Access Compliance Report Public Rights-of-Way (Curb Ramps)

Main Street: LARKSTONE_DR Cross Street: S_WOODLAND_ST Location: NW

ADA ID: RPAT211005121952 Ramp Type: Type 1 - Perpendicular Diagonal Initial Pass/Fail: Fail Overall Compliance: No Severity Score: 4

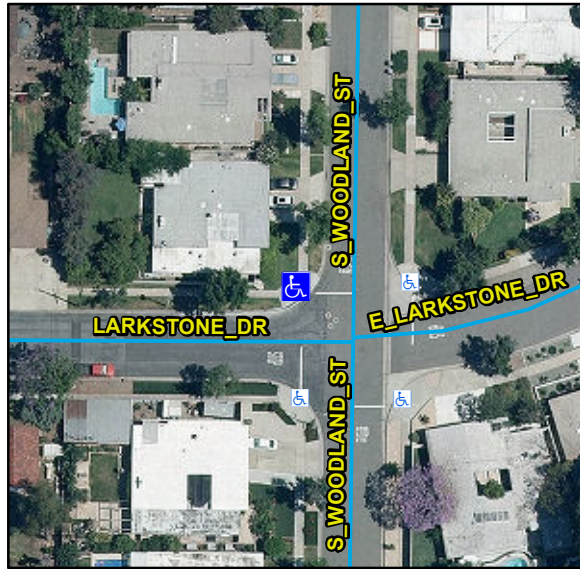
R304.2.2, R304.5.1, STD 1115

Remove & Replace Curb Ramp With Two New Directional Ramps or Equivalent.
